MAINE TURNPIKE AUTHORITY

ADDENDUM NO. 3

CONTRACT 2018.13

GUIDE SIGN MODIFICATIONS, PHASE III  
MAINE TURNPIKE EXITS 32, 36, 42, 44, AND 45  
**MILE 16.9 TO 63.0**

STA 2186+20.00  
OHSS I-95 MM 44.19\_N  
PROPOSED CONDITION

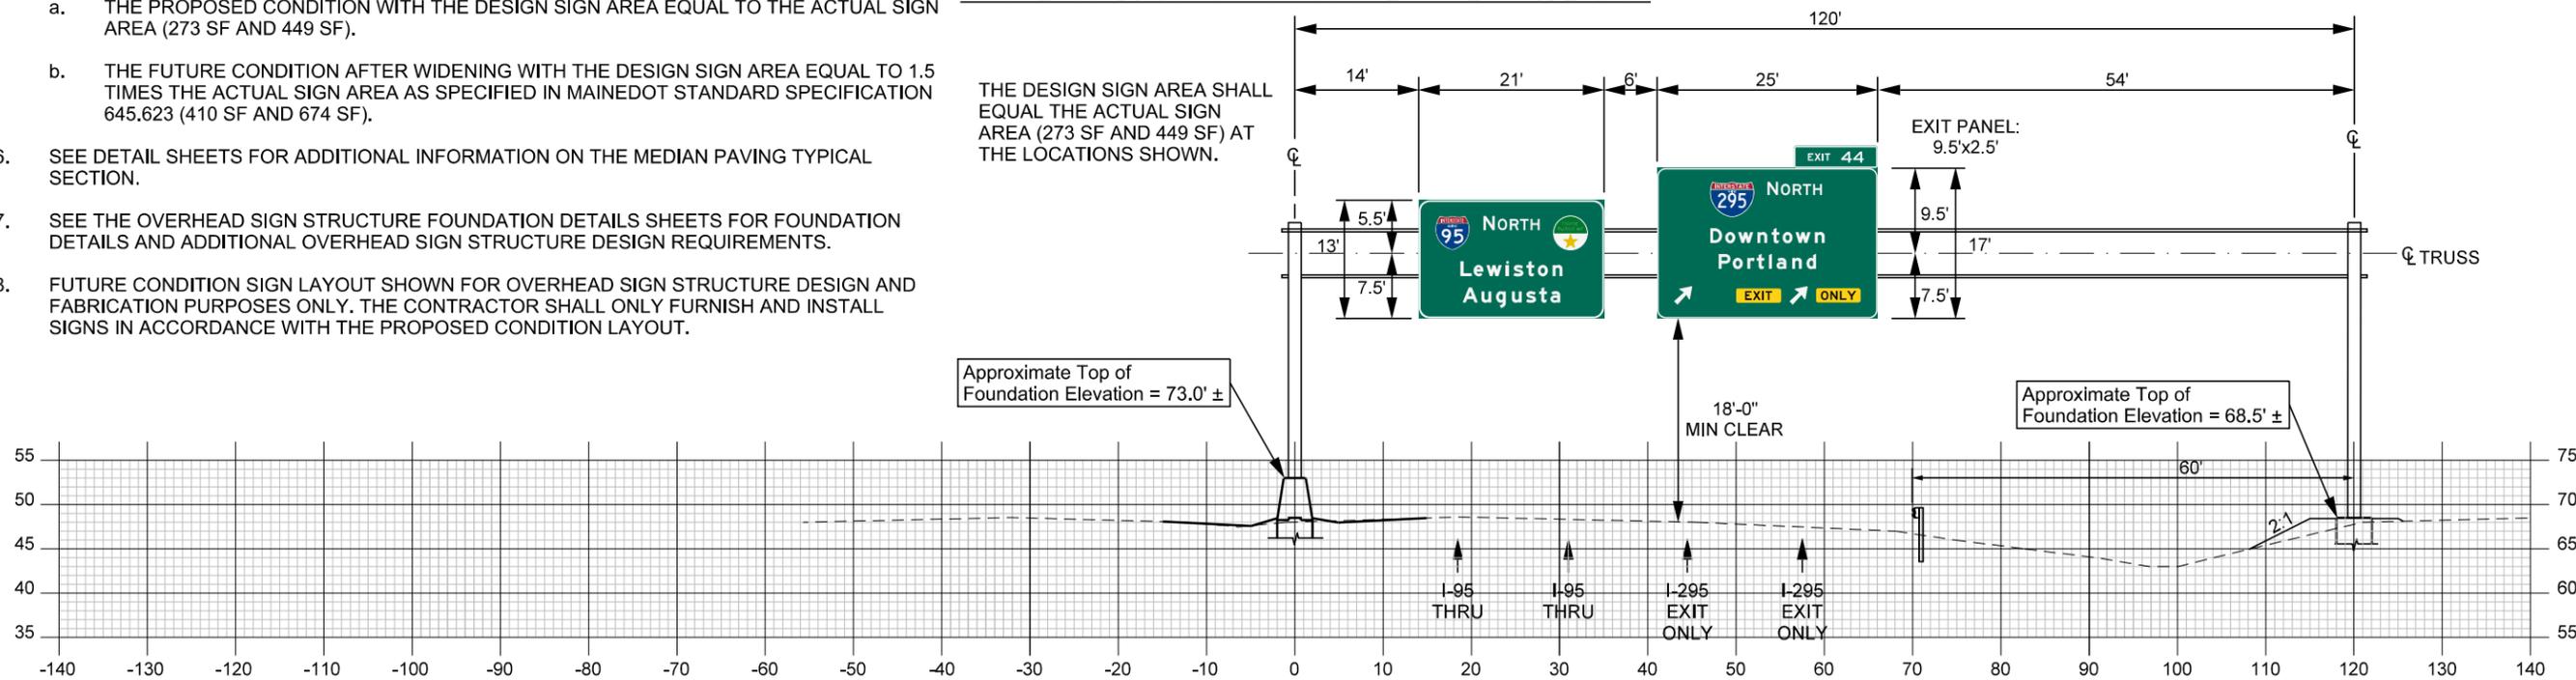
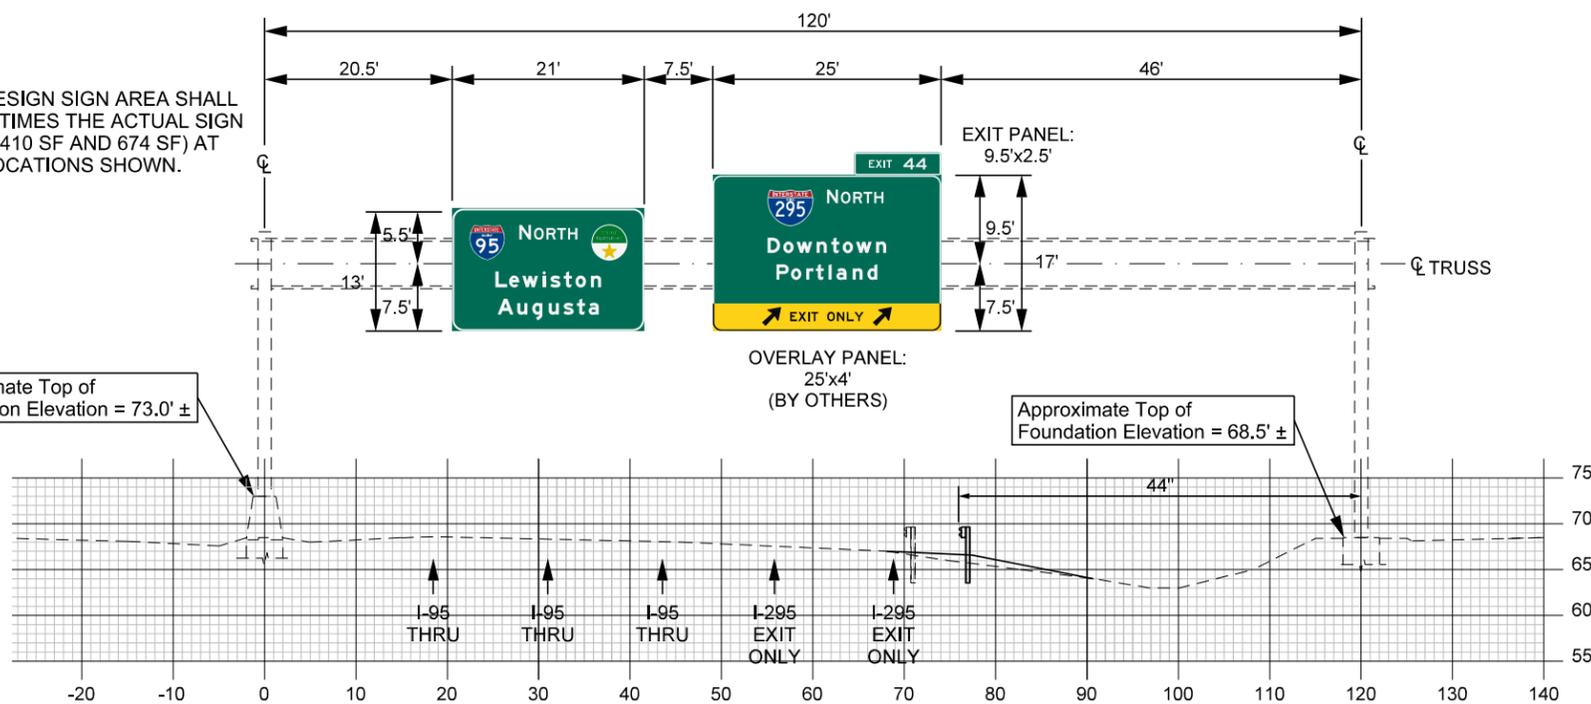
In the Contract Plans, **REMOVE** Sheet 91 and **REPLACE** with the attached Sheet 91 that modifies the proposed signs on the new overhead sign structure, relocates the overhead sign structure to the gore area, and installs new underdrain to bypass the median foundation.

SHEET NUMBER: 35

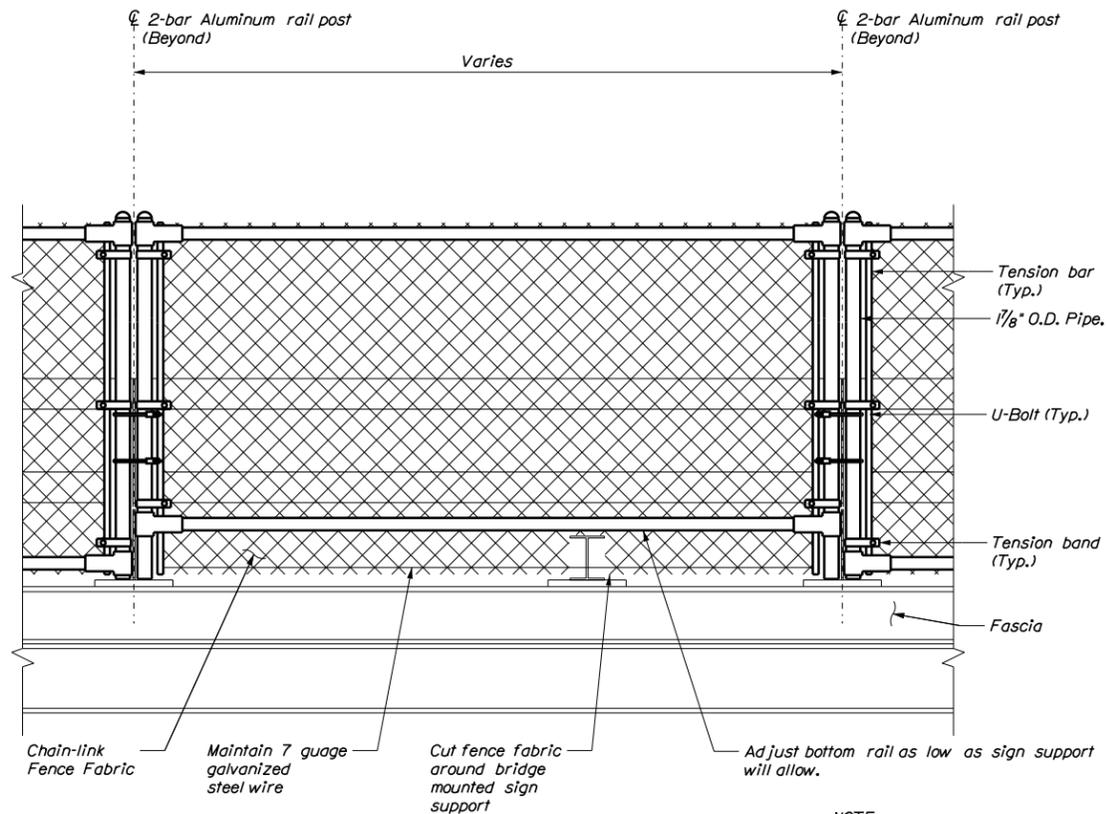
In the Contract Plans, **REMOVE** Sheet 35 and **REPLACE** with the attached Sheet 35 that modifies the paving detail and adds new guardrail terminal end details with guardrail notes. The title block has been revised to be show DETAILS (2 of 2).

SHEET NUMBER: 35A

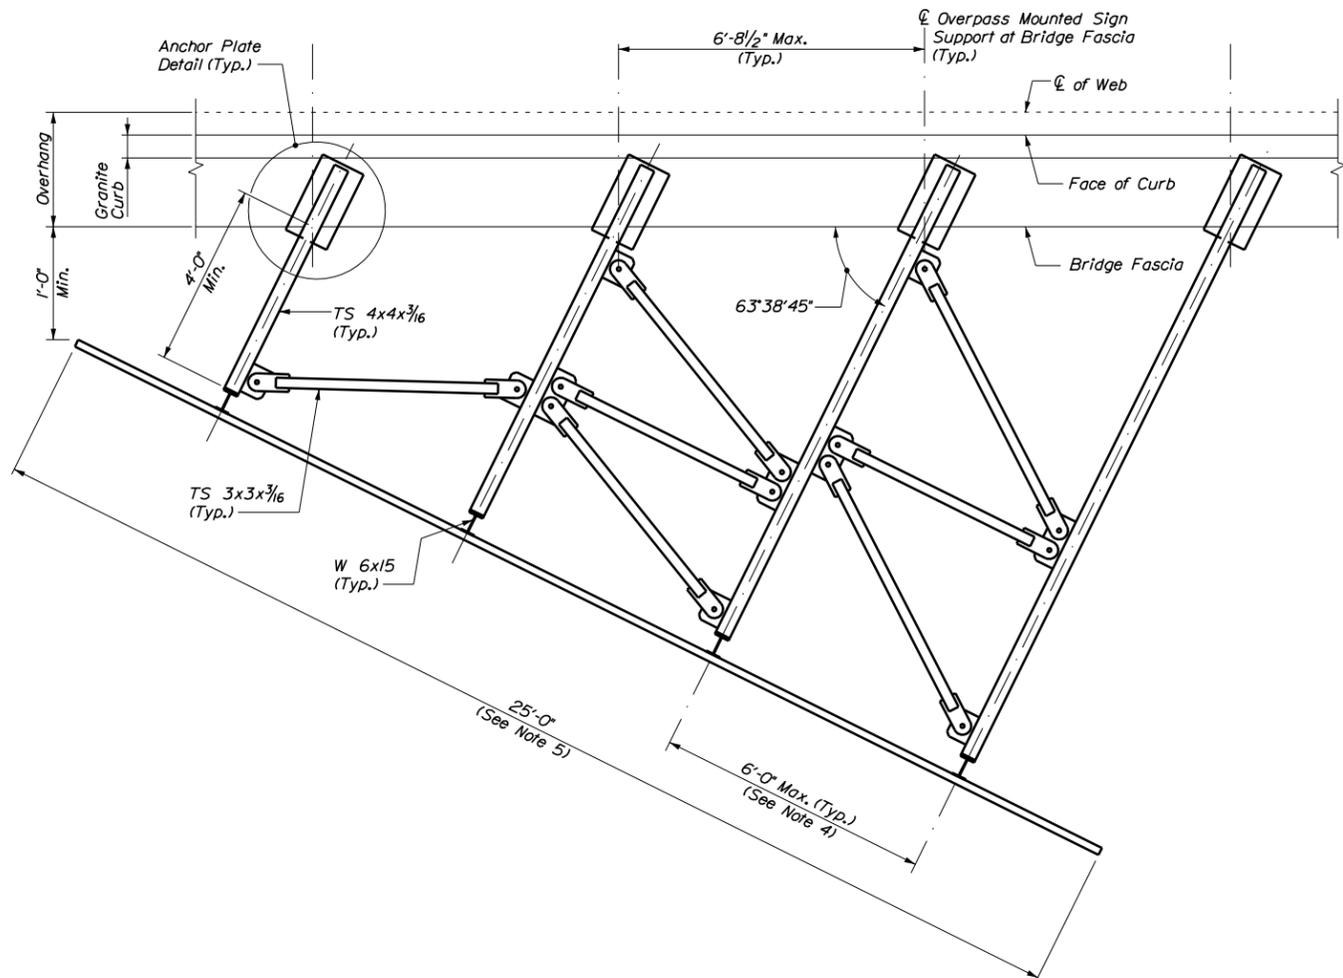
**ADD** the attached Sheets 35A, 35B and 35C to the Contract Plans for the modification of snow fence detail and for the specific designs for the bridge overpass mounted sign supports at Gorham Road.

SHEET NUMBER: 60

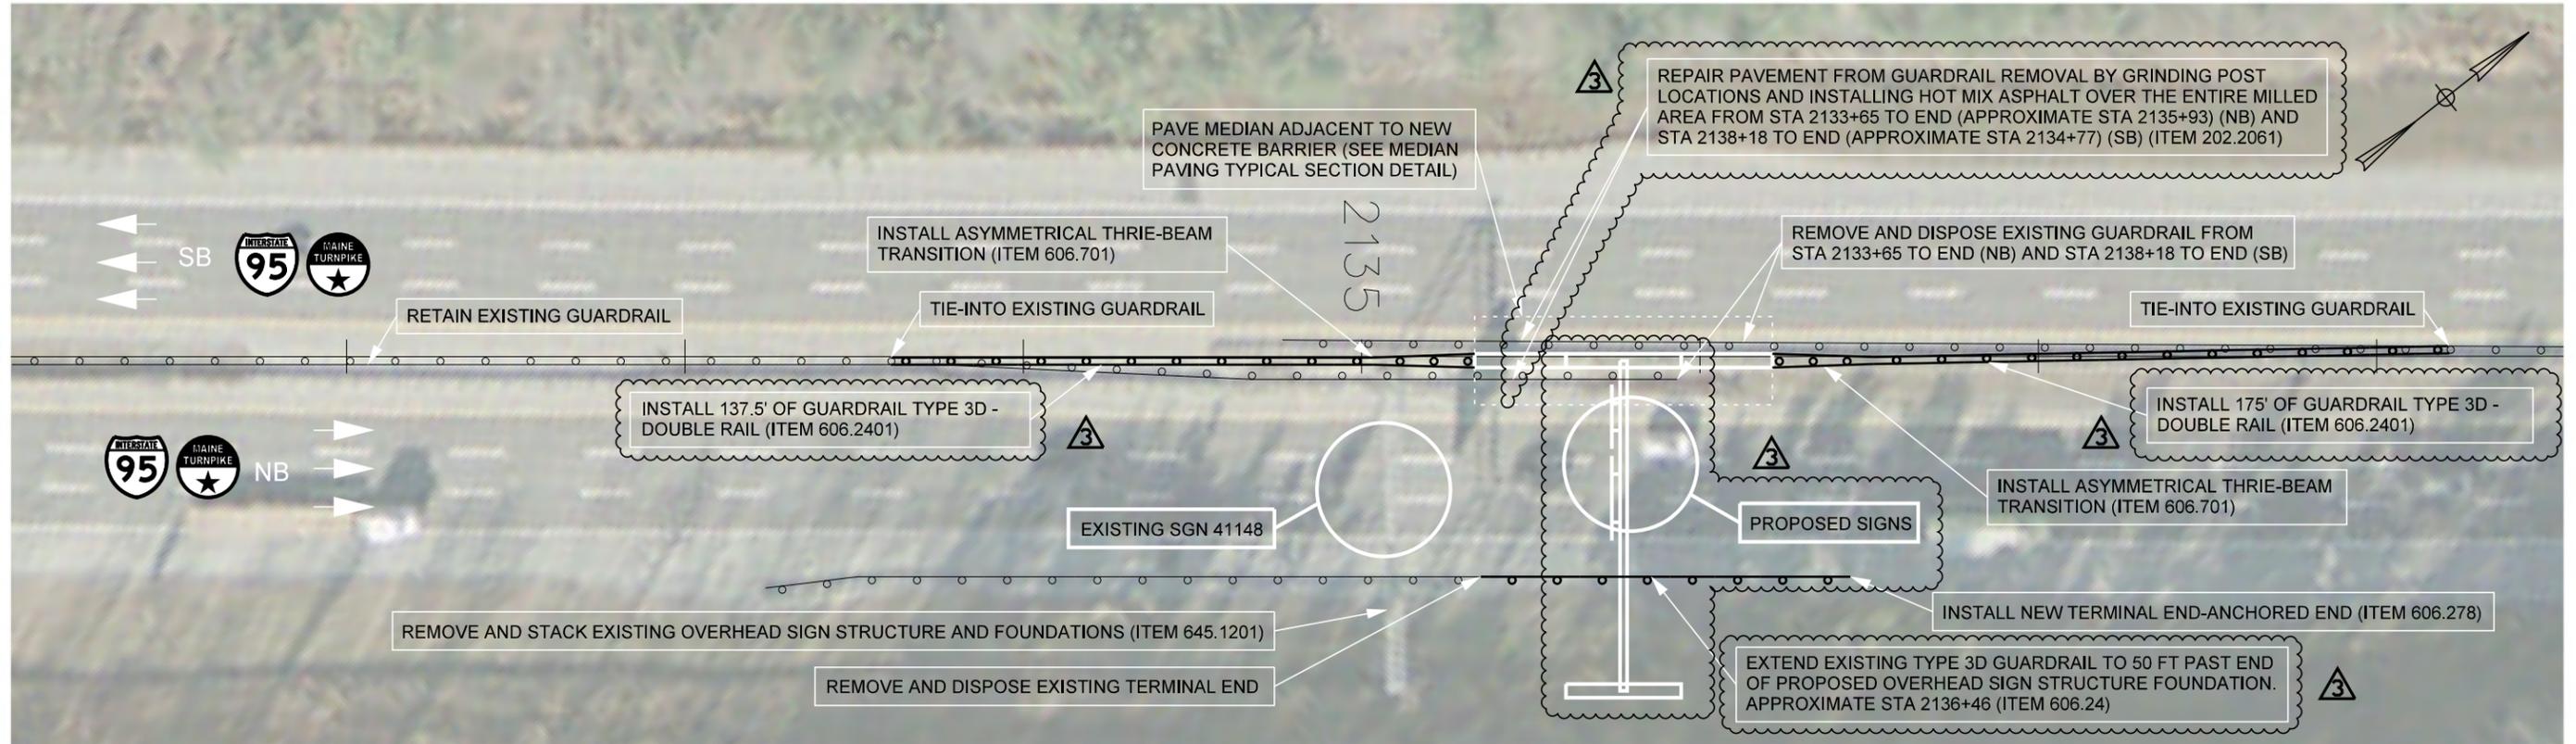
In the Contract Plans, **REMOVE** Sheet 60 and **REPLACE** with the attached Sheet 60 that clarifies the plan view to show that the proposed sign is mounted to the existing supports and not at a new location on new supports. This revised sheet also modifies the removed sign from Remove and Stack to Remove and Dispose.

SHEET NUMBER: 89

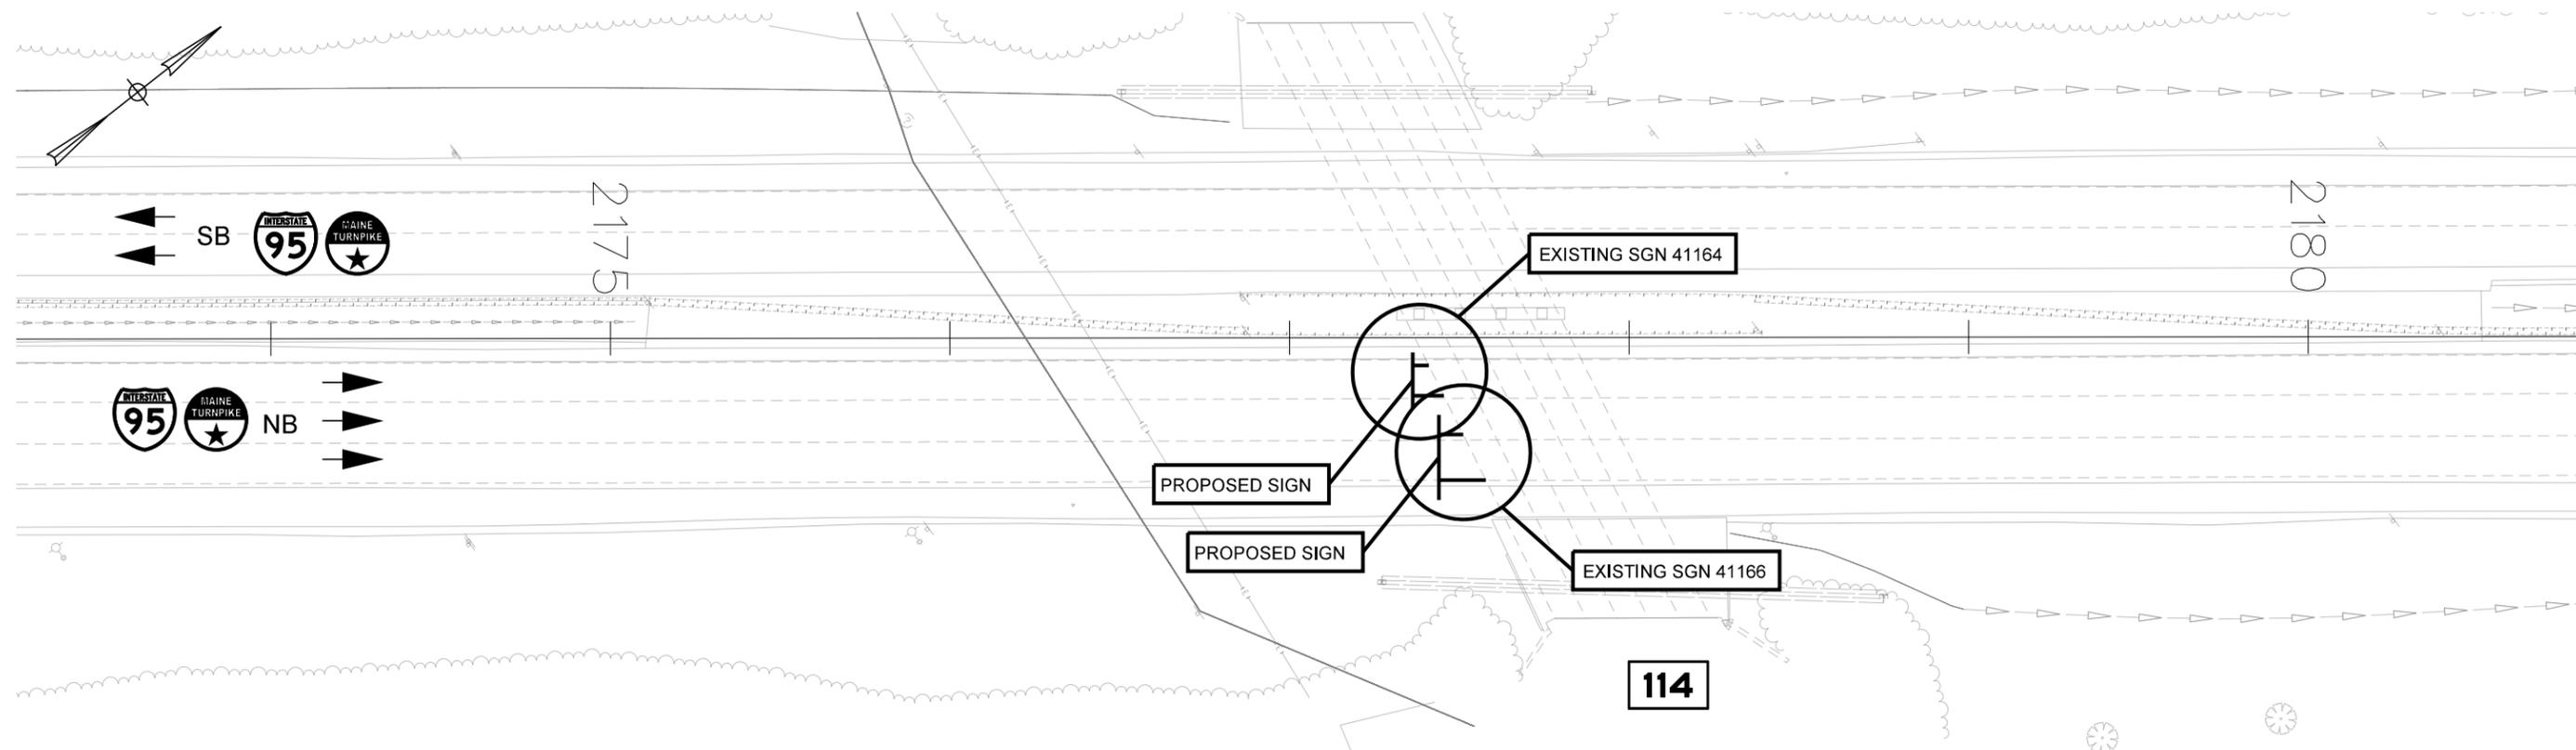
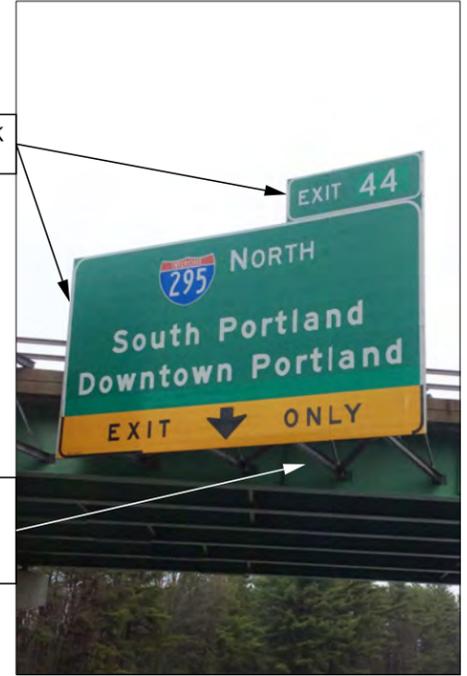
In the Contract Plans, **REMOVE** Sheet 89 and **REPLACE** with the attached Sheet 89 that modifies the proposed signs on the new overhead sign structure.

EXISTING GM I-95 MM 61.75\_N (MTA SGN 41749) SIGN FACE

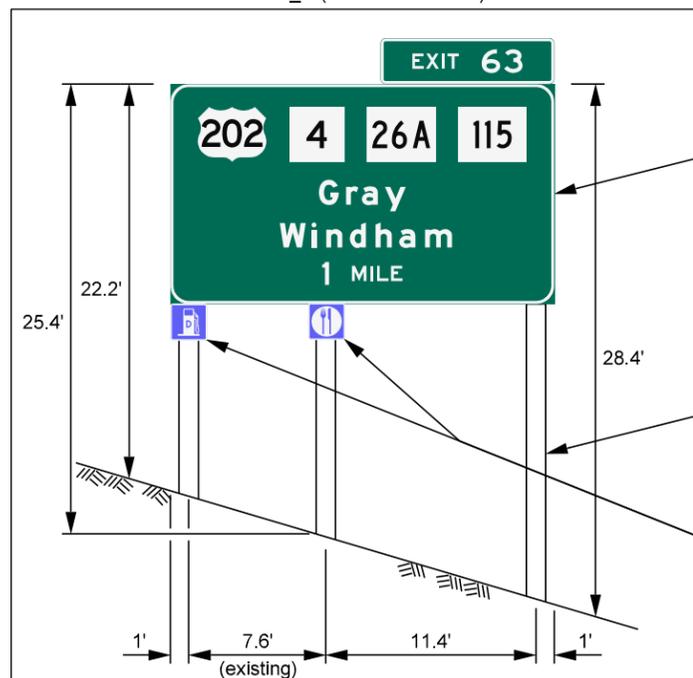
**ADD** the attached Sheet 101A to the Contract Plans for the modification to the existing sign at I-95 MM 61.75\_N (Sign #6120).
